ADDENDUM NUMBER TWO
EXIT 298 LIFT STATION & FORCE MAIN

Subject: Addendum No. 2 to the Bid Form and Plans for the City of Elko Exit 298 Lift Station and Force Main Project

This addendum is intended to address the questions that were presented to the City of Elko during the Pre-Bid Conference and Site Visit that took place on September 6th, 2023 at 2PM. Included below is a list of the questions presented and responses from the City of Elko and the design team.

D1.5

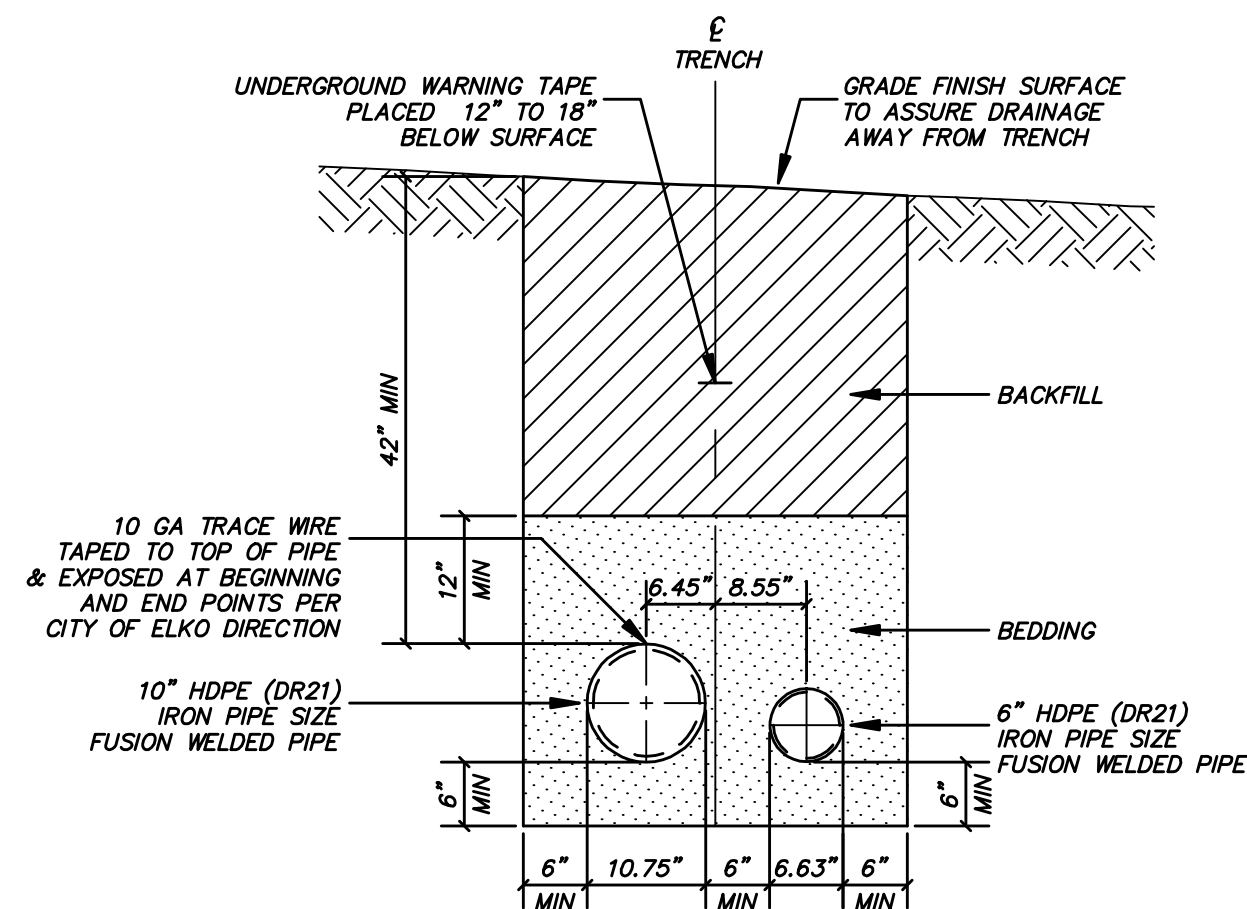
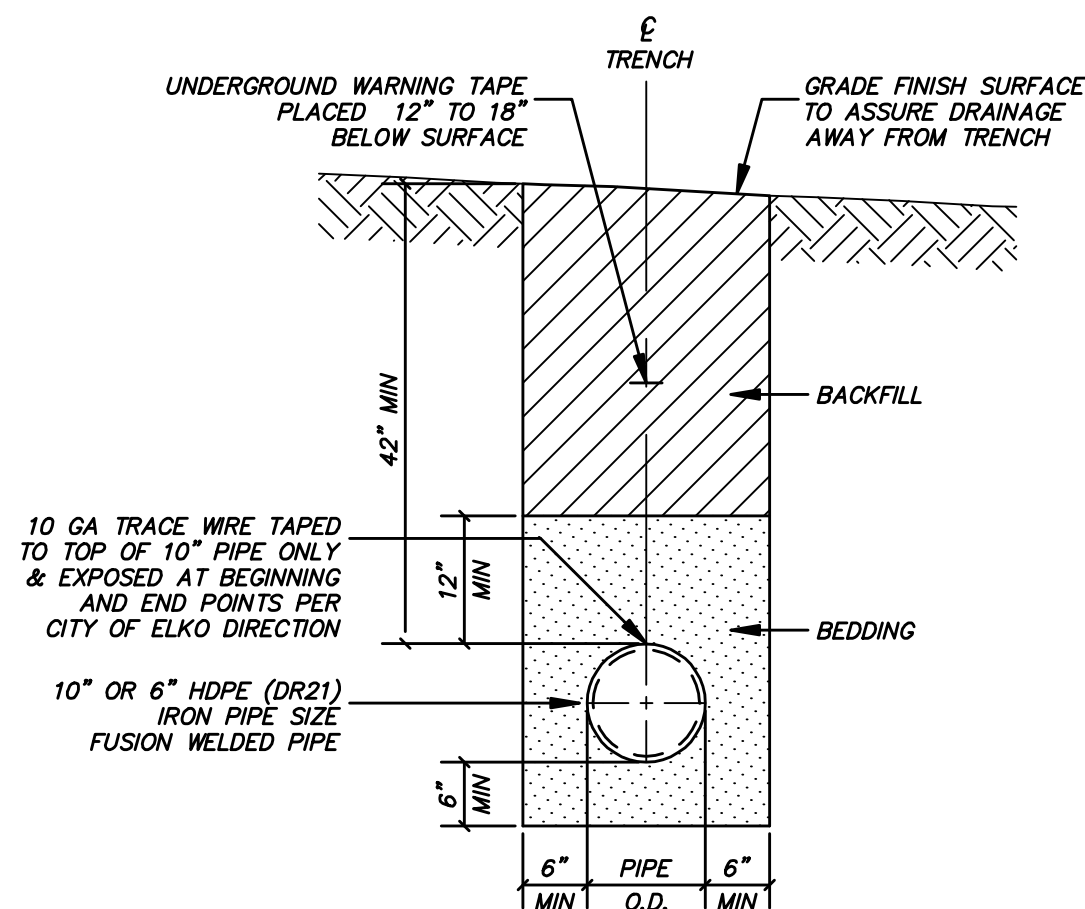
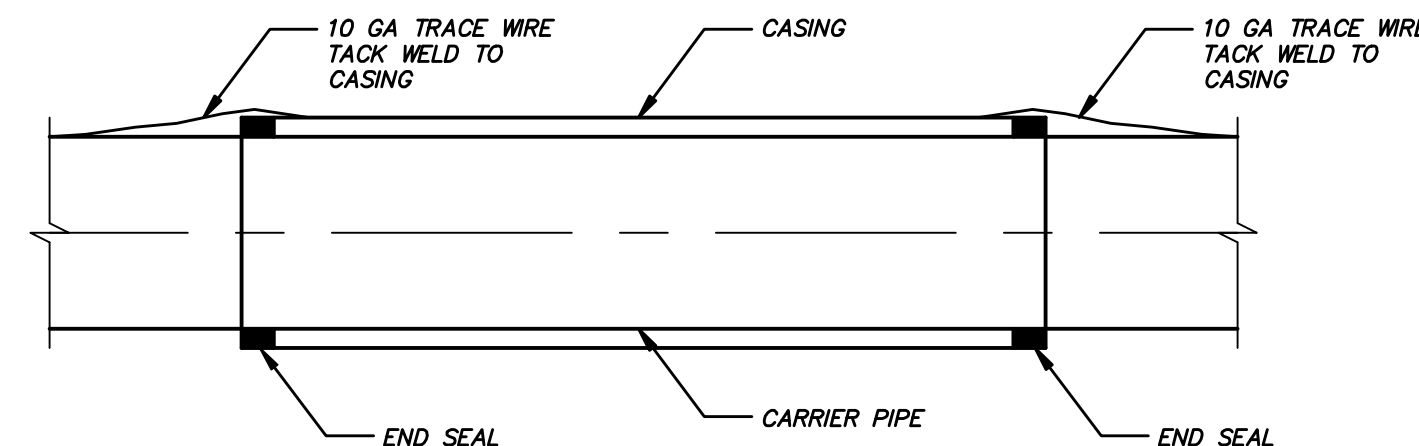
Q. Is de-beading required on the HDPE pipes?

Q. Is grout required at the casing and bores?

A. Class C Bedding material can be used (Clean Drain Rock). This should help with water issues in the area. See D1.5.

A. De-beading is required on the outside of the HDPE that will be placed inside the jack and bore pipe.

A. Weld beads will not be allowed on the interior of steel casing pipe.

A. Please see plan notes as this is discussed in detail on Sheet D1.5.

A. Casing ends can use AVANT AV 219 OAKUM or AV-LO2 Multifarious or Approved Equal.

A. An approved equal could be rubber boots for the casings.

A. Spacers are required.

A. See detail page D1.5.
